UNITED STATES PATENT AND TRADEMARK OFFICE

APPLICATION NO.	FILING DATE	FIRST NAMED INVENTOR	ATTORNEY DOCKET NO.	CONFIRMATION NO.
10/511,434	10/25/2004	Karl Robert Schafer	WI.1674PCT-US	4578

Office Action Summary

DETAILED ACTION

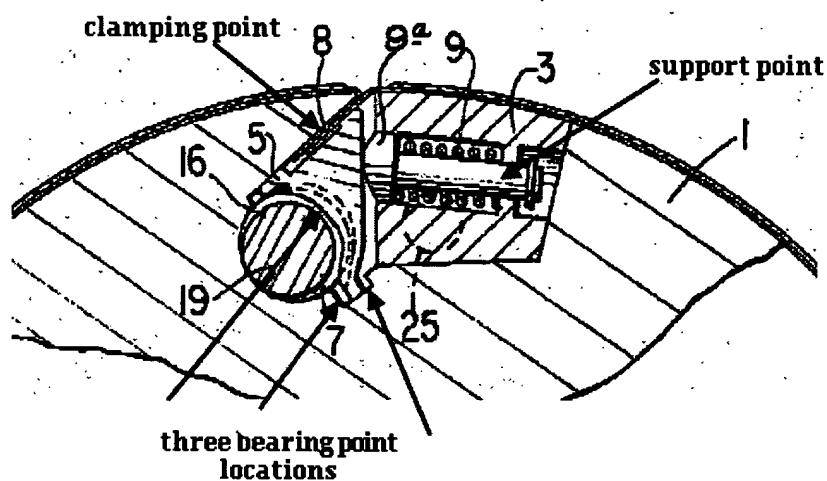
With respect to claim 51, note each of the bearing point(s) shown in the marked-up copy of Figure 6 of Luehrs can broadly be considered to be “adjacent” a bottom surface of the groove as recited.

Luehrs teach a trailing end leg clamping means to clamp either a plate or blanket arrangement 10, 11 including a clamping element pivotable lever 4, 5 supported for pivotable movement in a bearing point (see marked up Figure 6 above) opposite the opening of the groove, a spring 9, 9a engageable with the pivotable lever and engageable (at least indirectly) with one of the first and second walls at a support point, the pivotable lever holding the trailing end leg in a clamping point against one of the first and second opening walls opposite the support point, the spring 9, 9a providing a counterforce holding the pivotable lever in the bearing point. Again attention is invited to the above set forth rejection of claim 39 and the marked up copy of Figure 6 attached above. In view of this teaching, it would have been obvious to one of ordinary skill in the art to use the clamping arrangement shown in Luehrs as the clamping structure in both the forme cylinder and transfer cylinder of Holm as it would simply require the obvious substitution of one known clamping structure for another to provide a simplified clamping mechanism for securing the plate ends.
